Bid Addendum No. 1 for:

MASON TRANSIT AUTHORITY – PEAR ORCHARD PARK AND RIDE PROJECT

All Bidders are required to make the following substitutions to the Bid Documents. Below is a description of the revisions made to the Contract Documents.

DRAWING No.: SD-1
SHEET No.: 8 OF 23

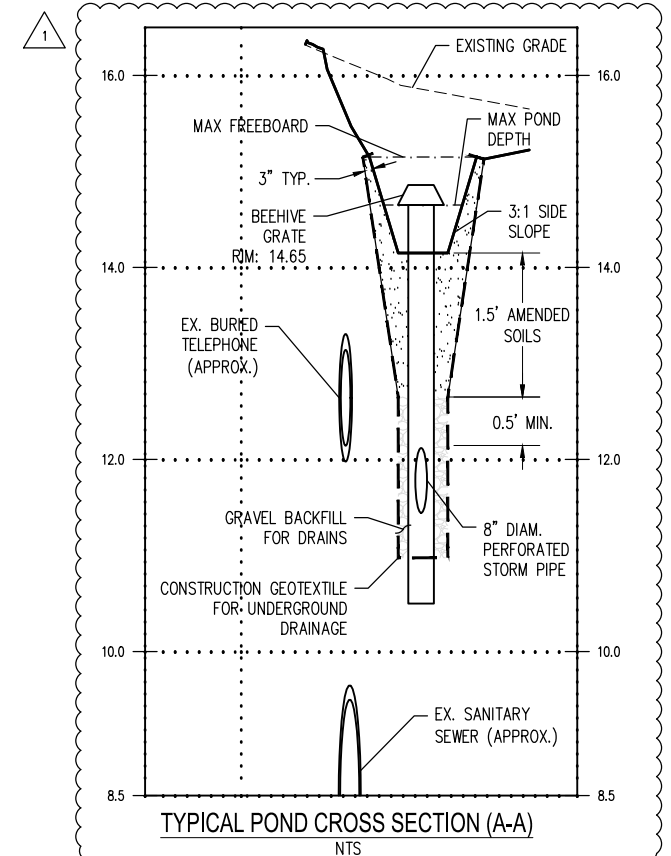
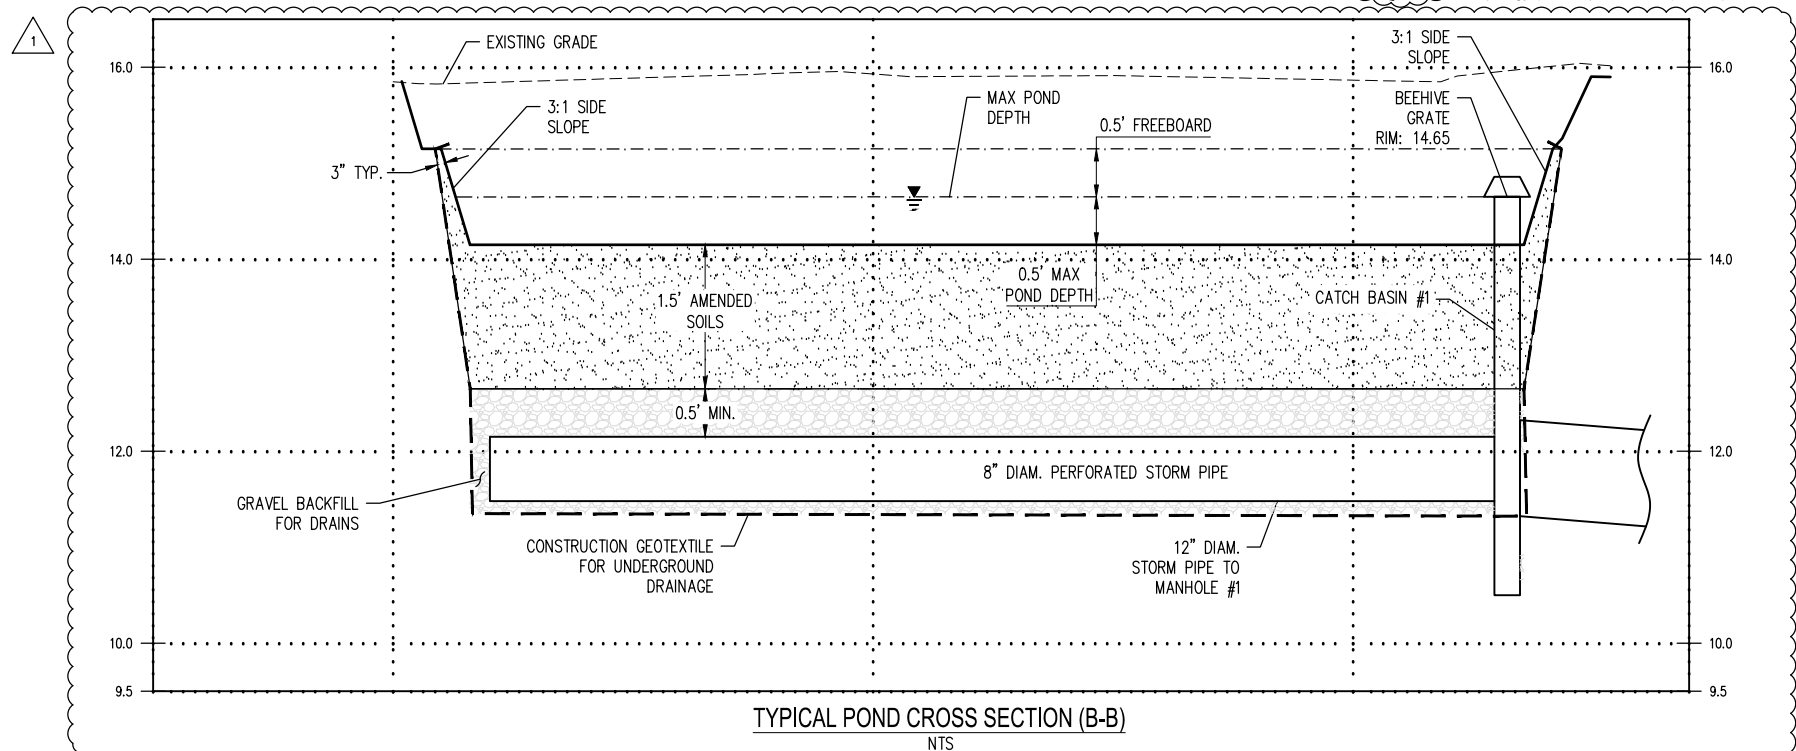
- Revised pond extents and updated pond cross section.
- Re-aligned storm line to go under sidewalk.
- Revised south parking lot grading.

DRAWING No.: SD-2
SHEET No.: 9 OF 23

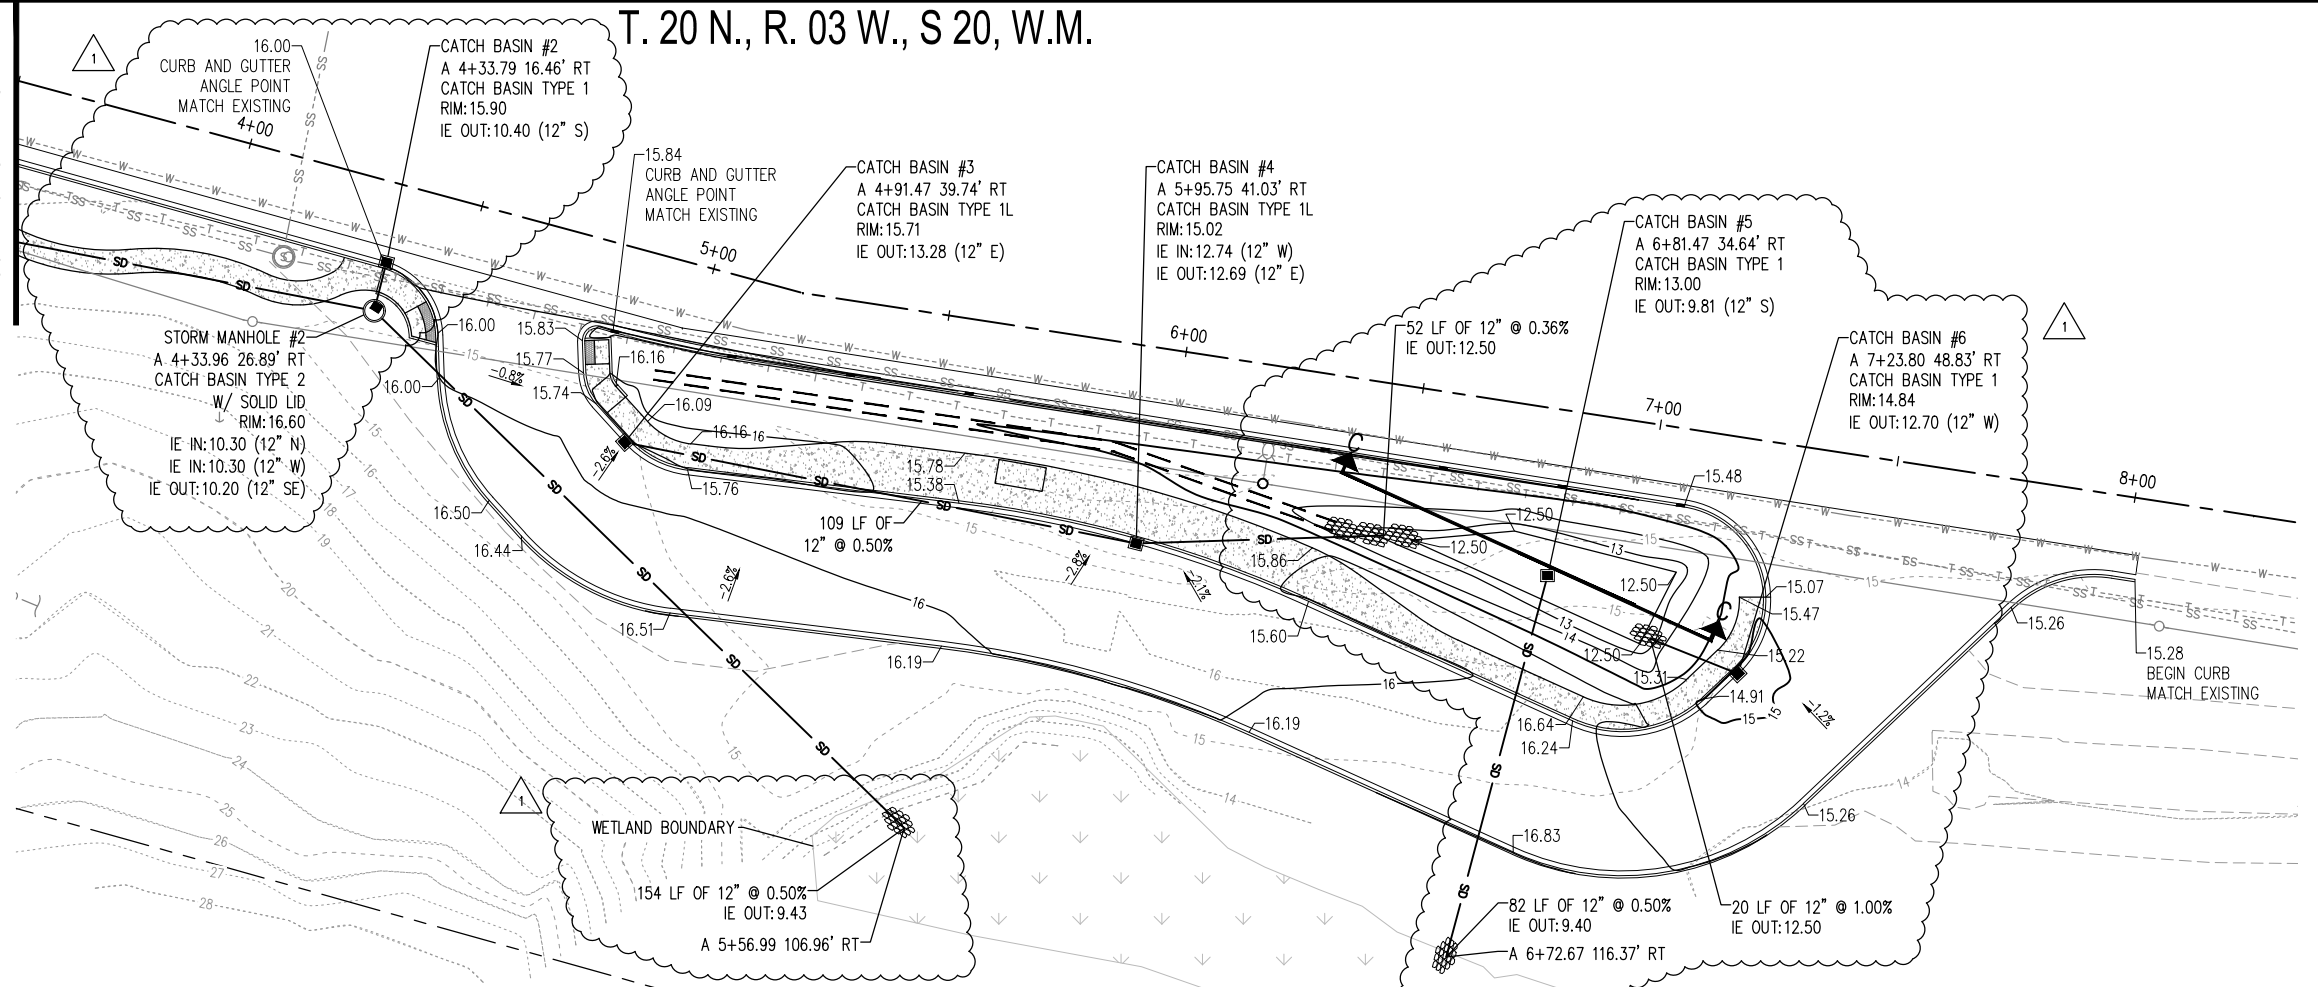
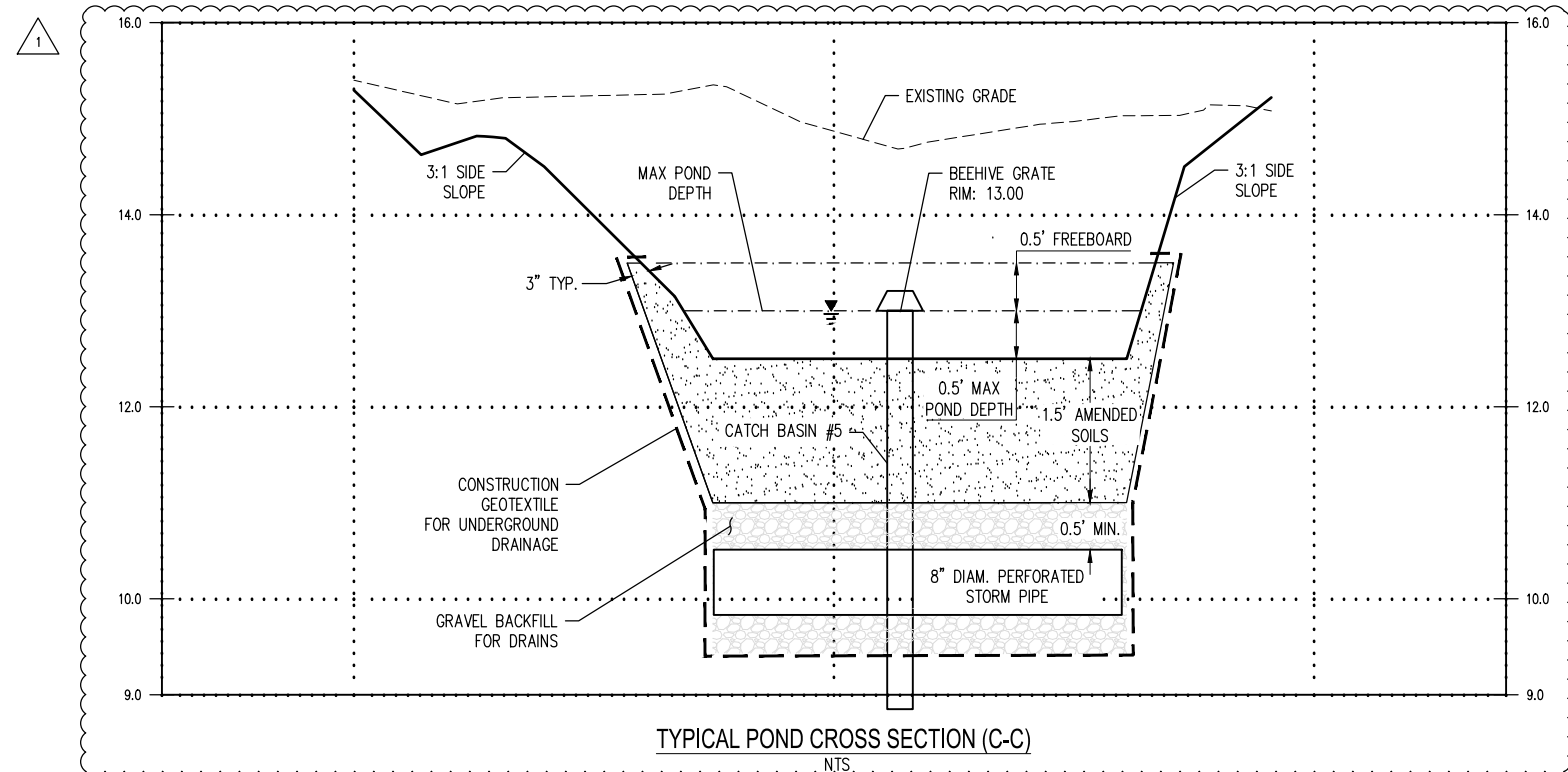
- Revised pond extents and updated pond cross section.
- Re-aligned storm line.
- Updated pipe outfall information.

DRAWING No.: SD-3
 SHEET No.: 10 OF 23

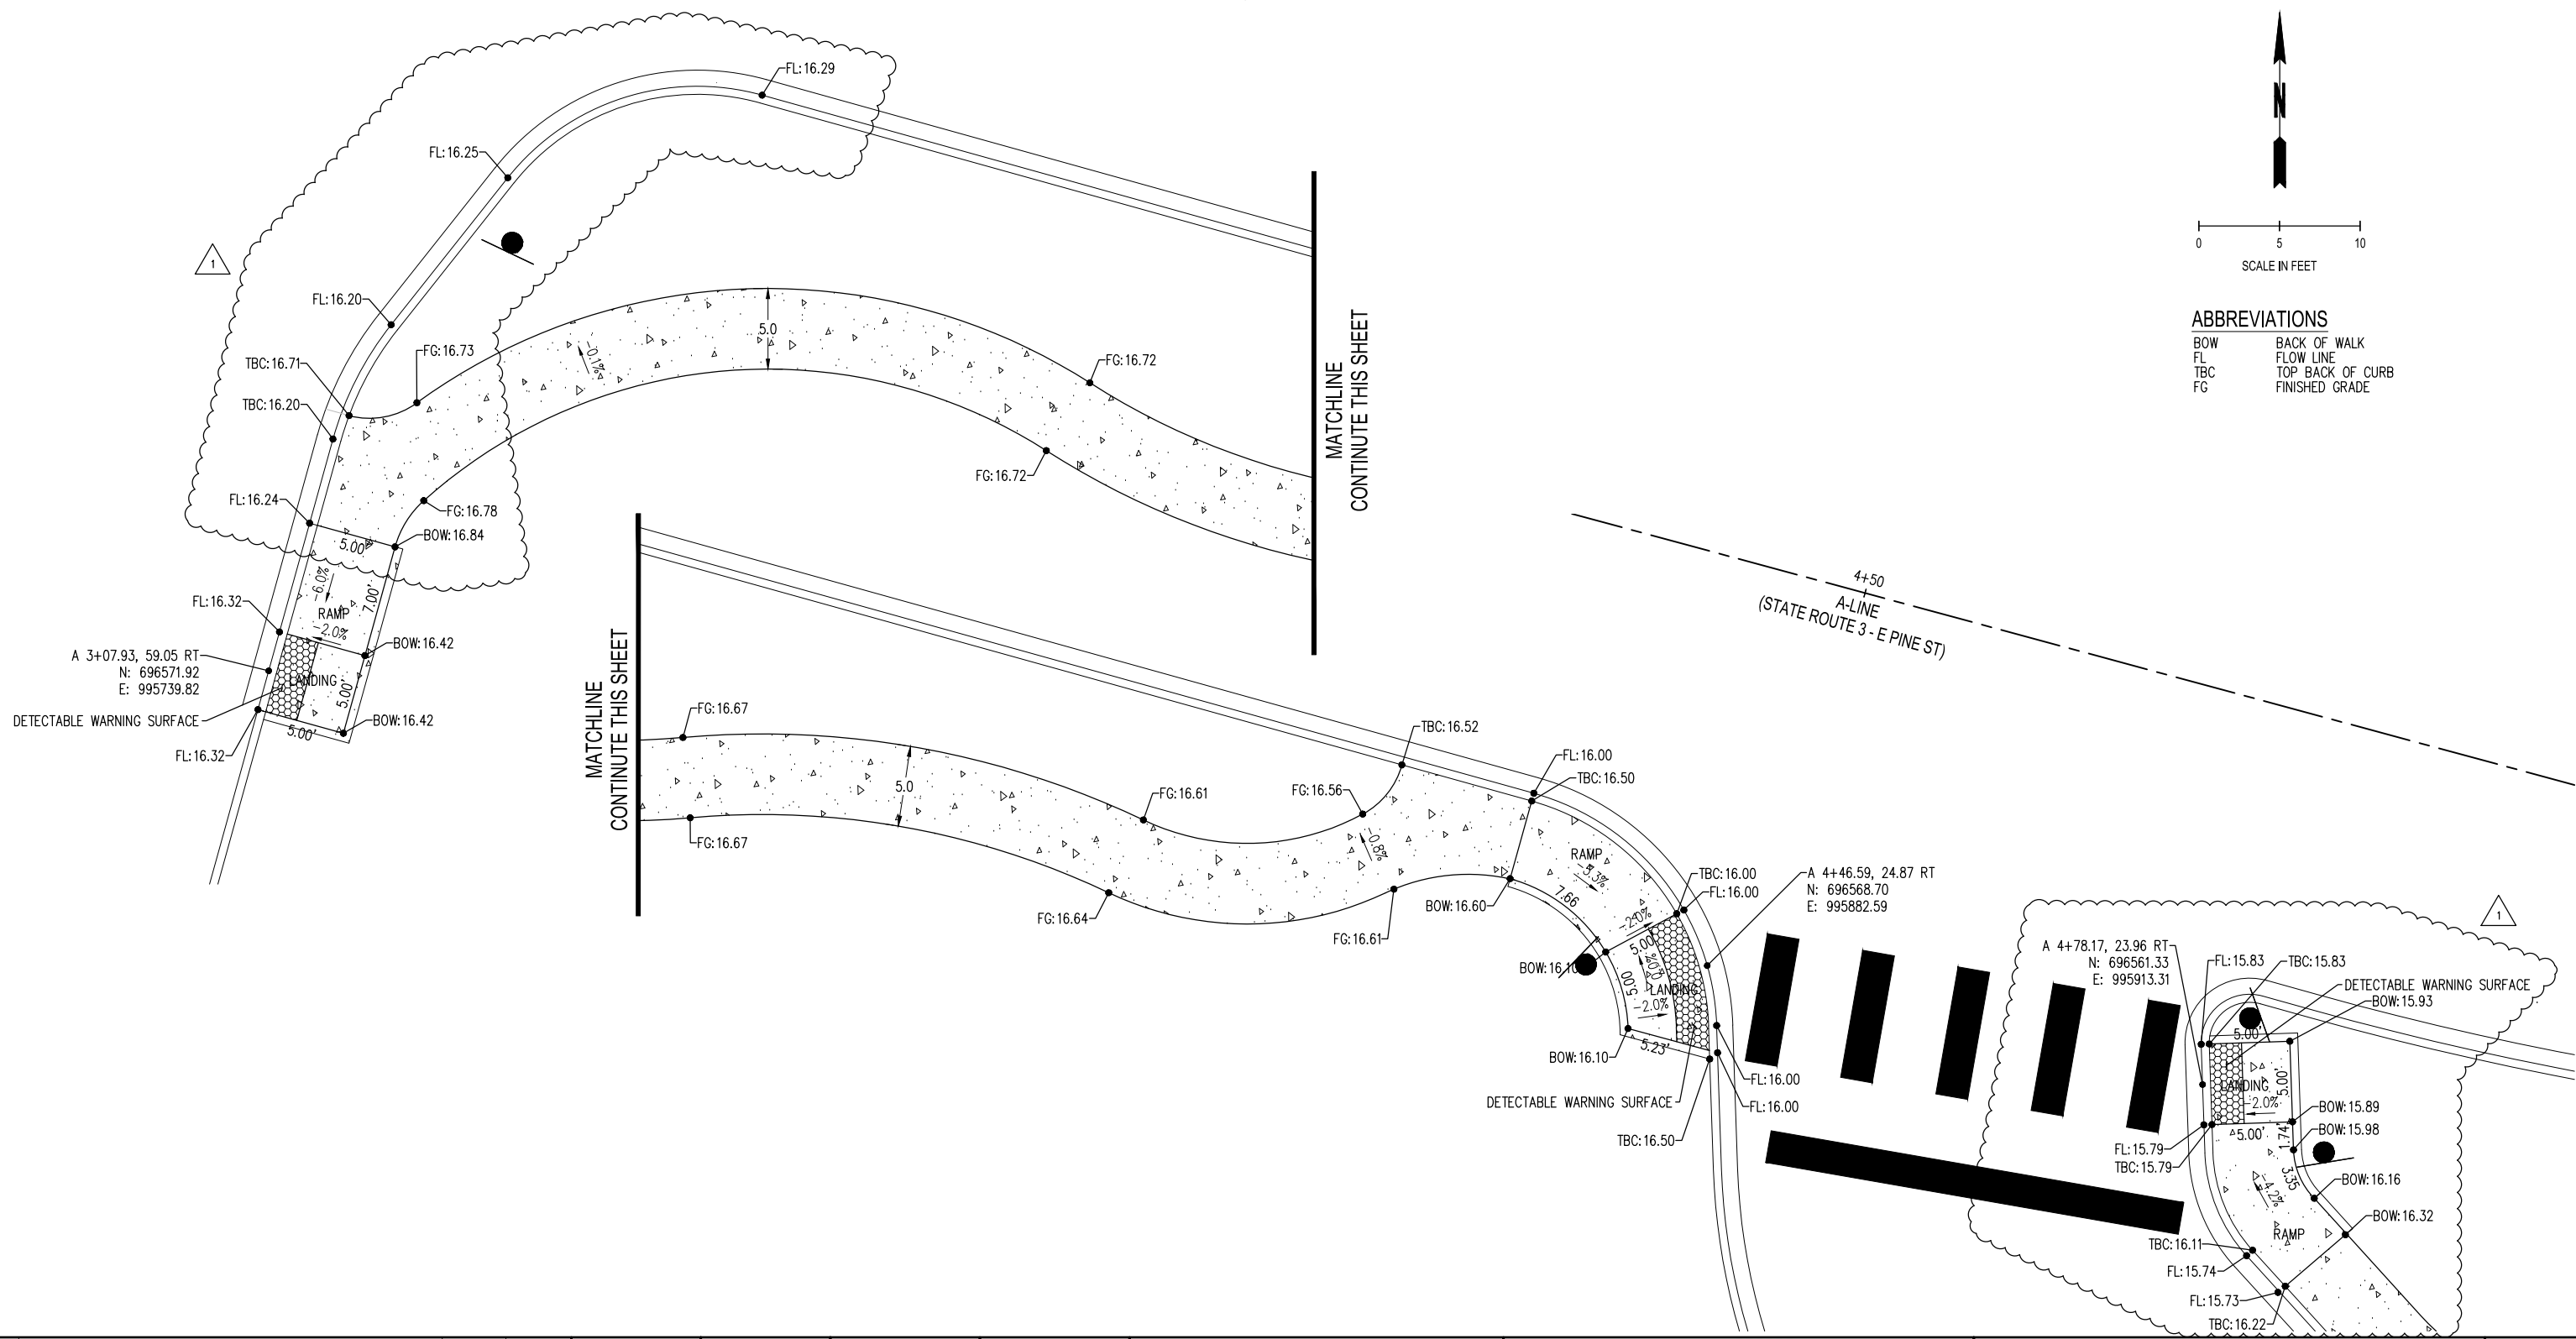
- Revised parking lot curb return geometry.
- Updated curb ramp callouts.

DRAWING No.:
UT-1

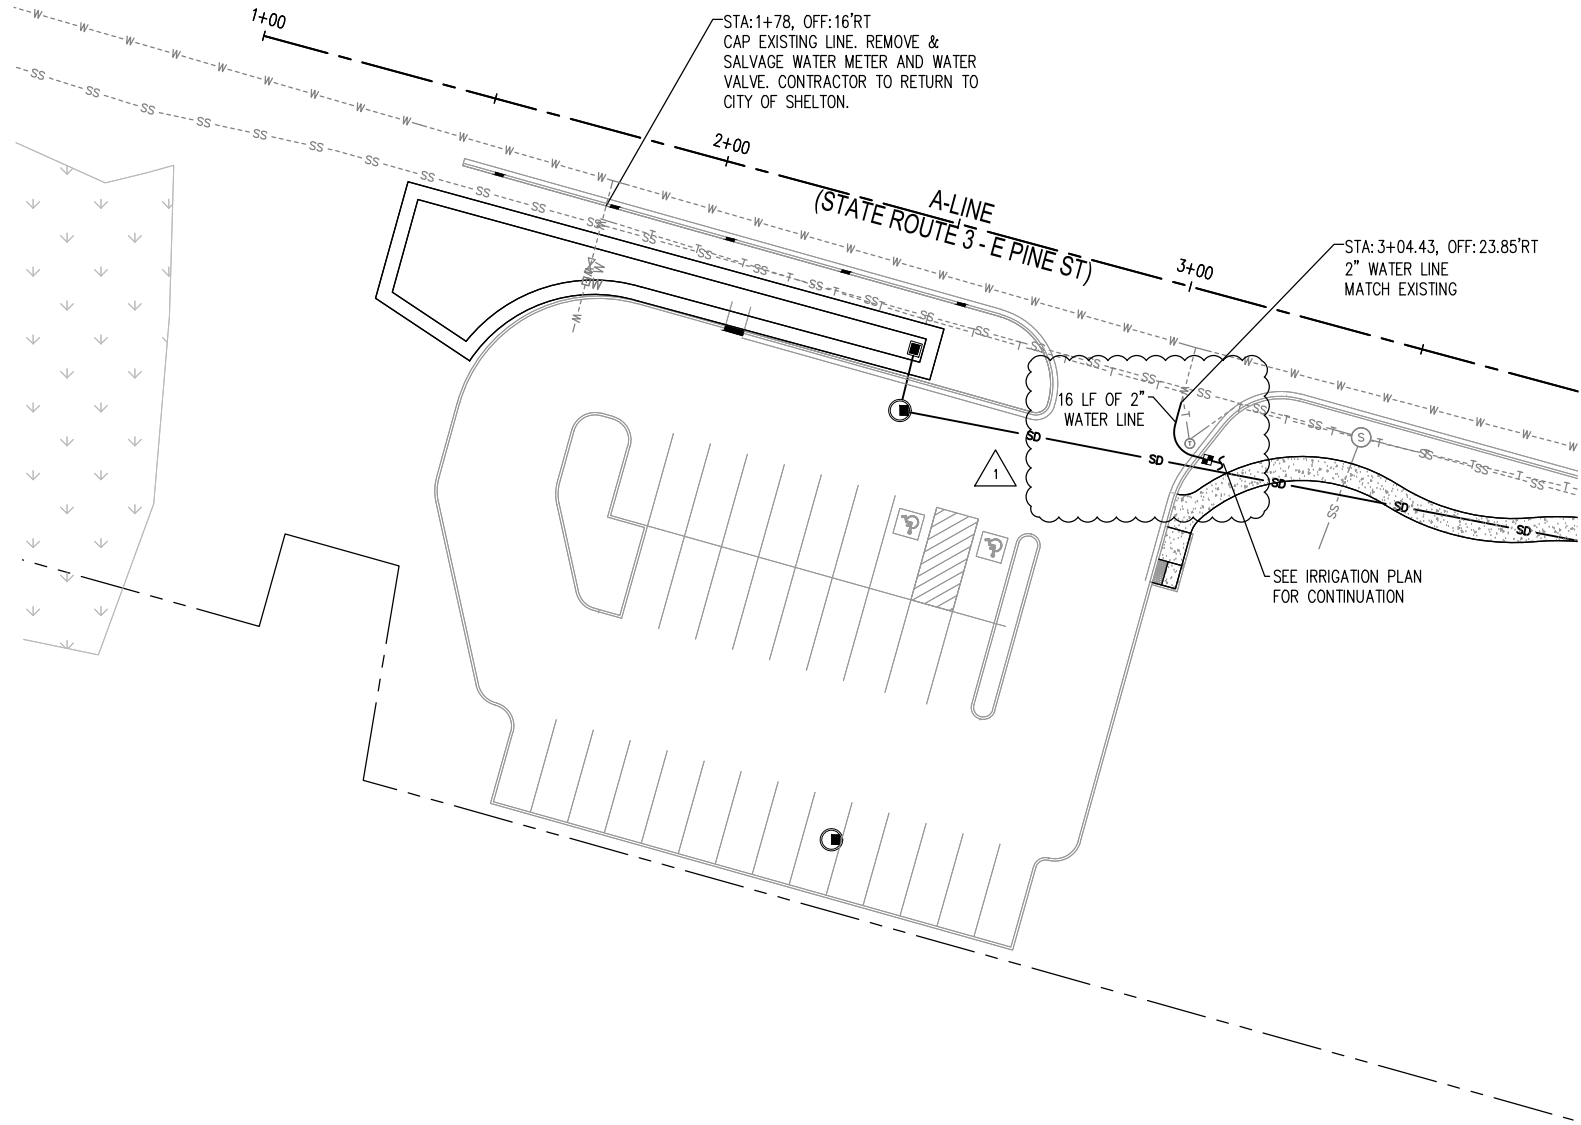
- Revised water connection per new storm layout and curb return.
